SEWAGE DISPOSAL SYSTEM

HOWARD COUNTY HEALTH DEPARTMENT

MEMORANDUM

RE: Building Permit #B00120676
5540 Ten Oaks Road
Proposed Addition to existing home and office

DEMOLITION PLAN scale 1/4" = 1'-0"

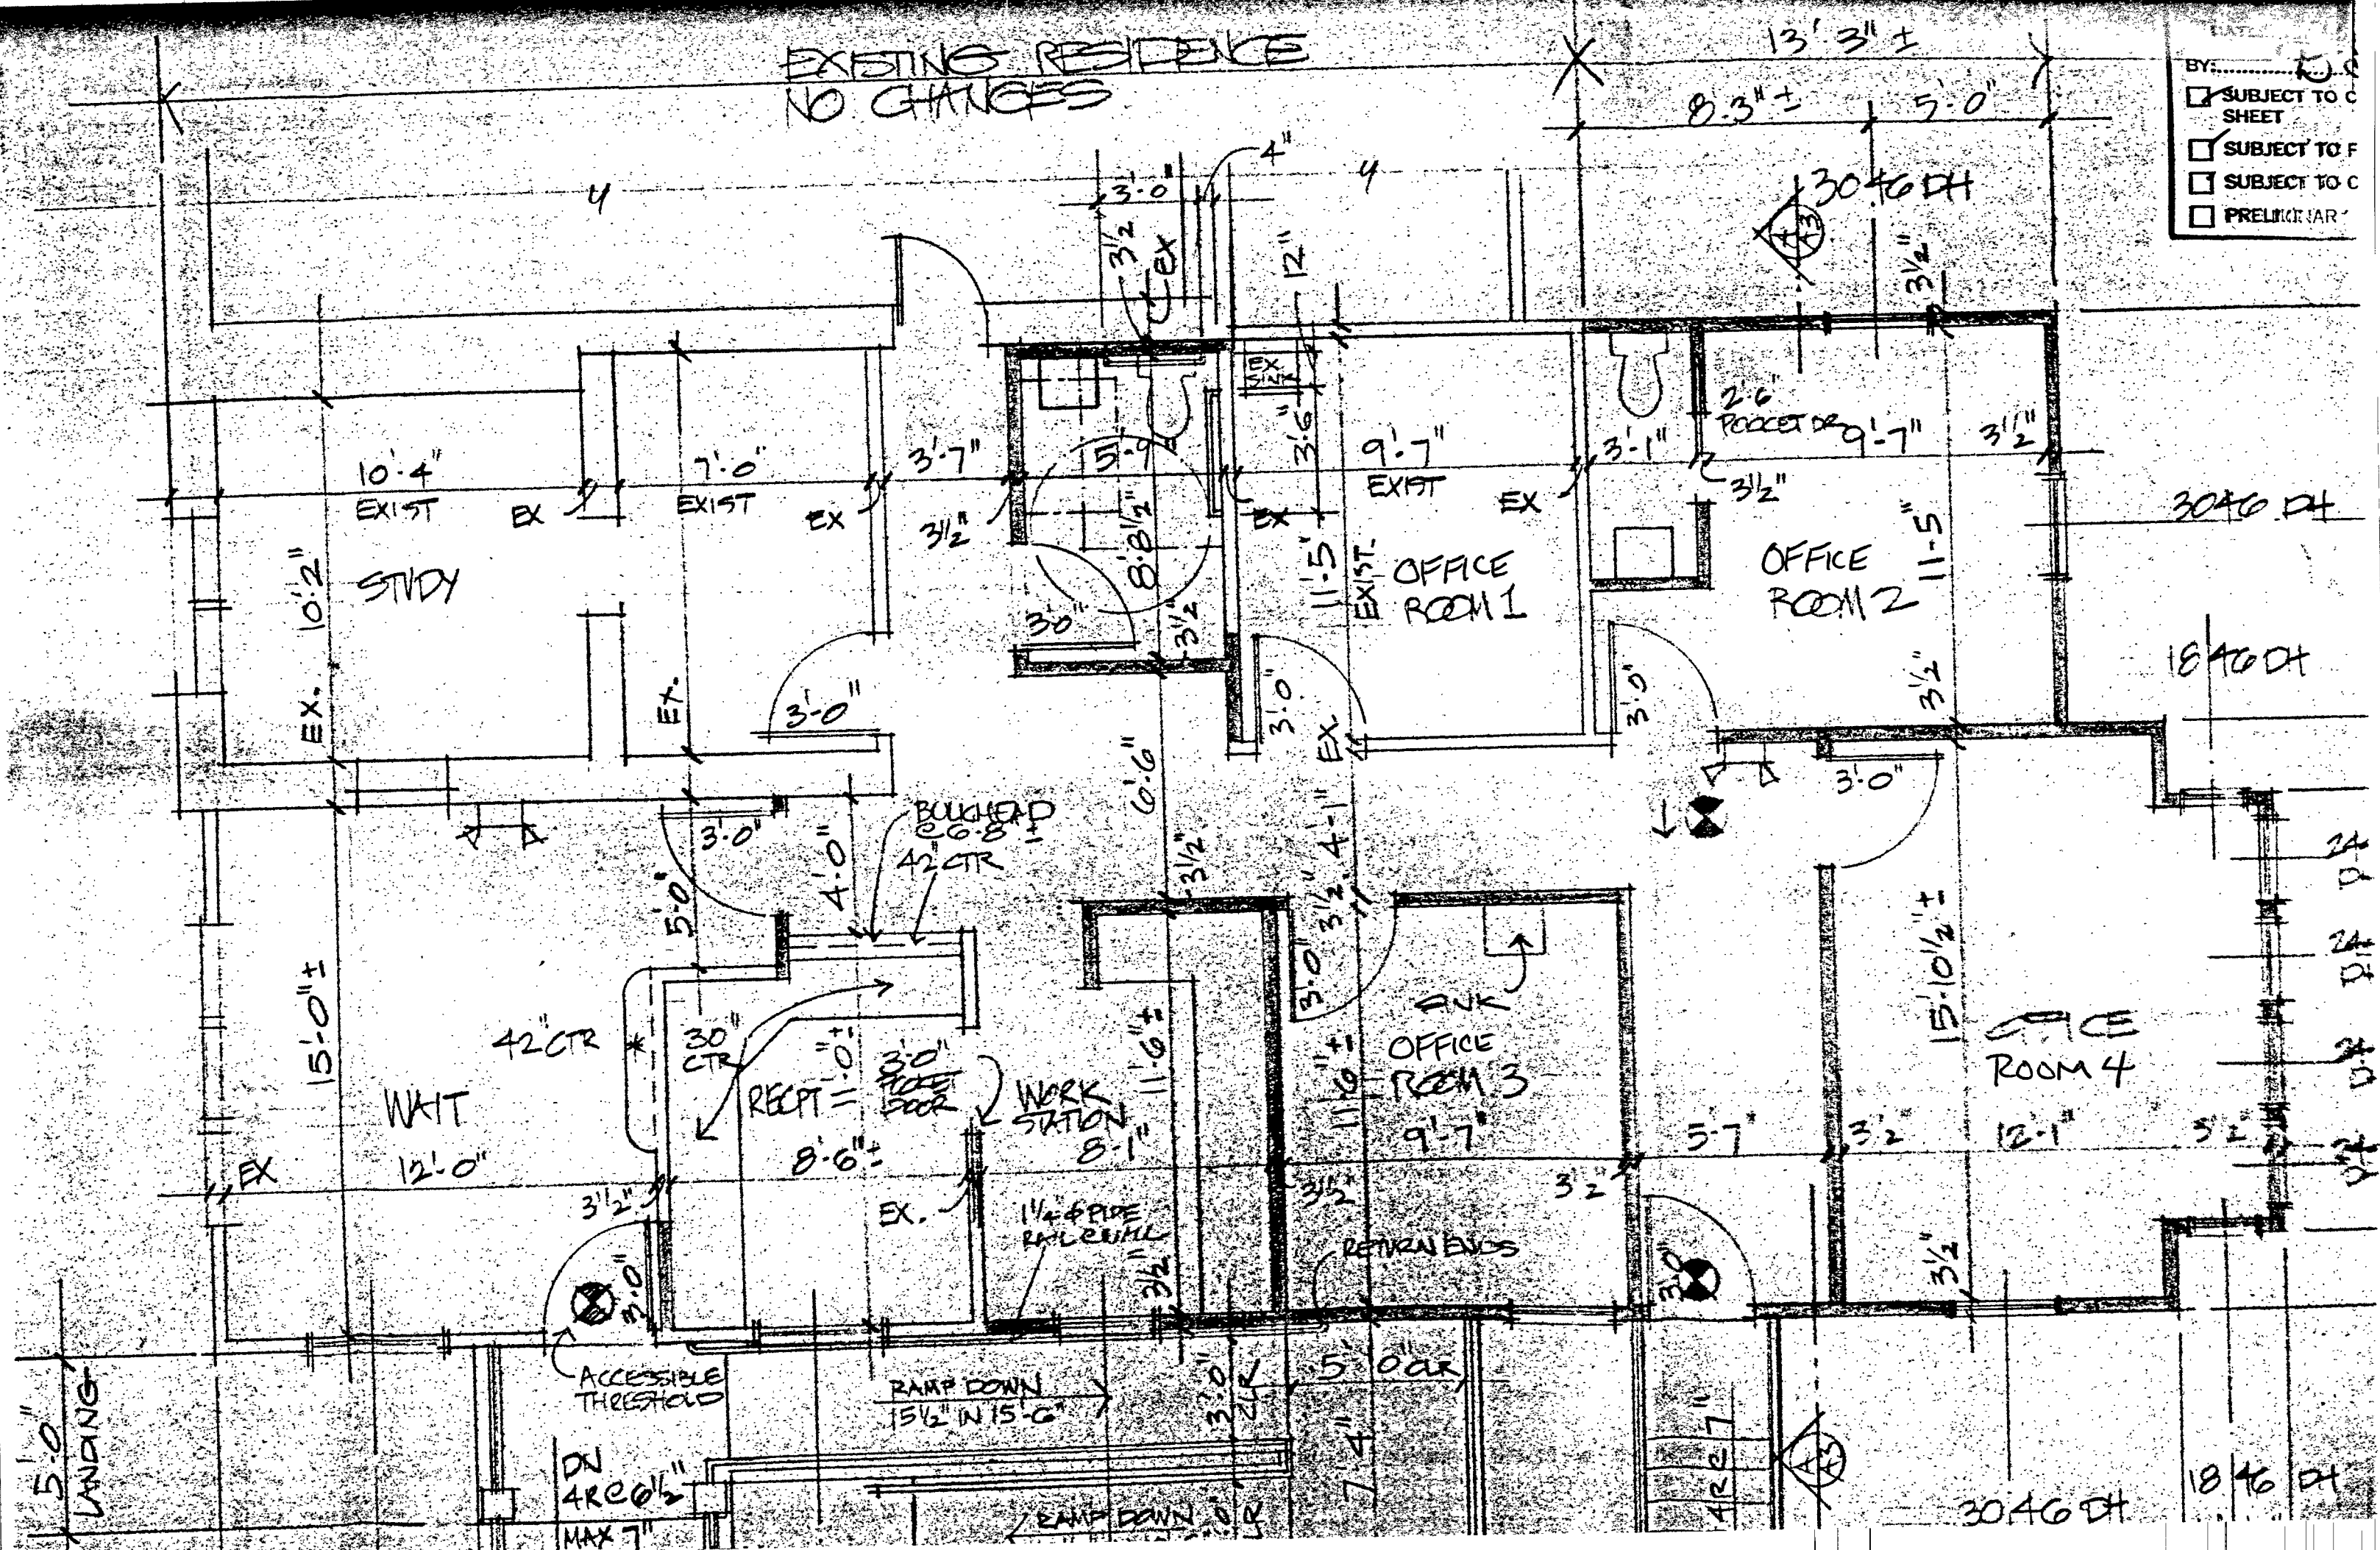
This office has recently received the above referenced building permit application; however, we are unable to recommend approval of the application at this time. The application indicates a proposal for an addition to the existing house and office, including additional office rooms.

Using the information provided on the application, the Health Department records for the property indicate that an upgrade to the original septic system was installed in 1998. However, the existing septic system is seriously undersized to accommodate the potential increase in sewage flow that shall be generated by the proposed addition.

Prior to Health Department recommendation for building permit approval, the existing septic system shall require upgrade to accommodate the proposed addition. In order to continue with the proposal, please contact me at the address below or by calling (410) 313-2640 to request the septic repair permit (permit fee \$25.00) required to initiate the septic system upgrade evaluation.

Needs to have 1710 sq ft total NOW

135' trench

Also, need to establish SDA for
complete repair for FUTURE

Upgrade + reserve SDA must
be completed and approved
prior to HD approval of BP
